24 January 2024
Project #: WGA230679
Doc. WGA230679-LT-TT-0001_B
E: jack.h@watsonyoung.com.au

CAROLINE CHISHOLM CATHOLIC COLLEGE VET & STEM BUILDING - TRAFFIC ENGINEERING RFI RESPONSE

Figure 2.1: 2010 & 2023 Road Network Assessment Volumes

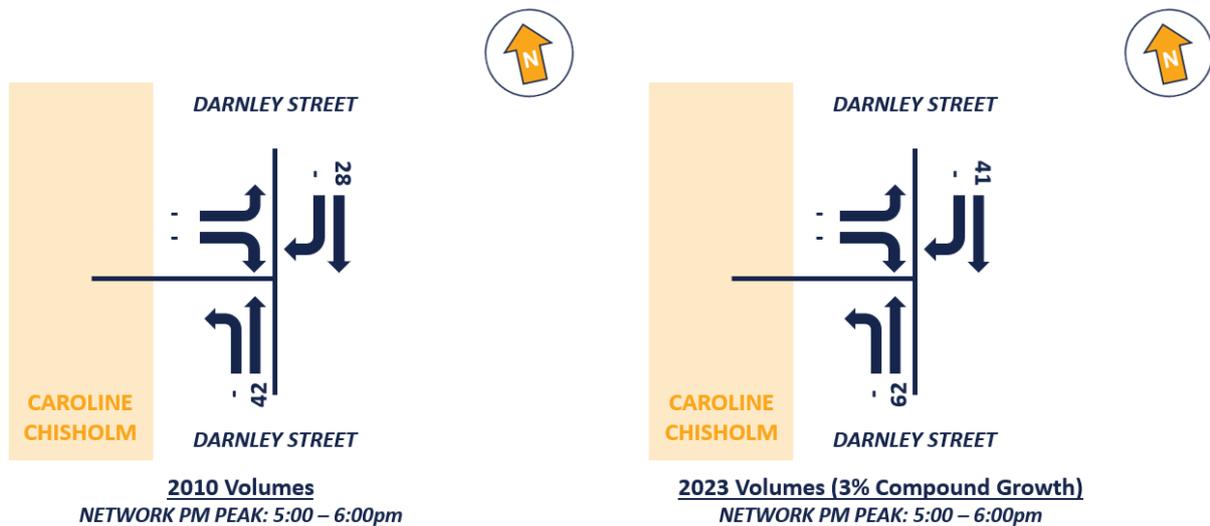
- d. A SIDRA analysis undertaken at the site access/Darnley Street during peak hours and after-hours use noting 145 vehicles exiting the car park in the PM peak for after-hours use;

As detailed in Section 5.2 of WGA's Traffic Impact Assessment (TIA) report 'WGA230679-RP-TT-0001' (dated 1 September 2023), current volumes are based on traffic surveys undertaken in 2010 and factored up by a 3% compound growth rate (13 years of growth). These volumes are illustrated in Figure 2.1.
